UNITED STATES PATENT AND TRADEMARK OFFICE

APPLICATION NO.	FILING DATE	FIRST NAMED INVENTOR	ATTORNEY DOCKET NO.	CONFIRMATION NO.
10/596,706	04/03/2007	Jens-Christian Meiners	UOM0324PUSA	2884
22045	7590	01/05/2011		
BROOKS KUSHMAN P.C. 1000 TOWN CENTER TWENTY-SECOND FLOOR SOUTHFIELD, MI 48075				
EXAMINER				
SOOHOO, TONY GLEN				
ART UNIT		PAPER NUMBER		
1774				
MAIL DATE		DELIVERY MODE		
01/05/2011		PAPER

Office Action Summary

DETAILED ACTION

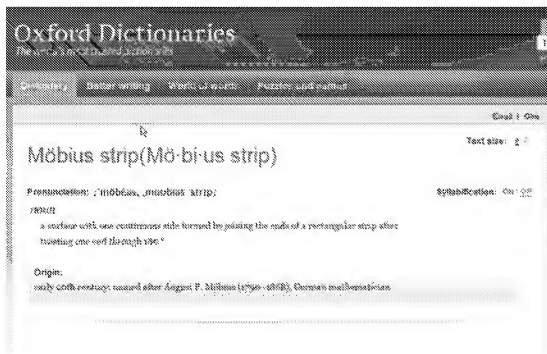
4. Claims 21-24 are rejected under 35 U.S.C. 112, first paragraph, because the specification, while being enabling for a mixer with channels and flow paths, does not reasonably provide enablement for mobius-like element(s), and microfluidic elements which "define a fluidic, flowing , mobius-like, topologic structure". The specification does not enable any person skilled in the art to which it pertains, or with which it is most nearly connected, to make the invention commensurate in scope with these claims. One can not determine the which structure is "mobius-like". The term "mobius" is not an commonly accepted definition and term in the art. The specification does not clearly define the structure of the "mobius-like" element and does not point to, or label the actual "mobius" element such that one may construct the element. One can not determine where the "mobius-like" element structurally ends and where the other structures of the channels, inlet and outlets begin and are connect to the "mobius-like" element.

5. The examiner has attempted to the use a dictionary meaning of "mobius". However a dictionary search does not clearly define or enable the meaning of "mobius" in a clear context of this application. "Mobius" is the surname of a 20th century

mathematician. A search of the dictionary does not define "mobius" solely, but only yields the phrase "mobius strip".

- 7.
8. No where in the drawings show the structural element which exhibits a single edged, one continuous sided surface of a mobius strip.
9. Applicant points to the paragraphs [0052], [0053], [0054], [0064], [0065] and [0060] of the specification in the published US pregrant publication 2007/0177458 as support to the claim language. However the vague contextual description in those

paragraphs does not add any further description to "mobius" such that the structure is clearly and adequately described and defined so as one may be able to make the structural element in connection with the other elements of the invention, and it does not place the public on notice to the structural equivalents that may patentably infringe upon applicant's "mobius" element.
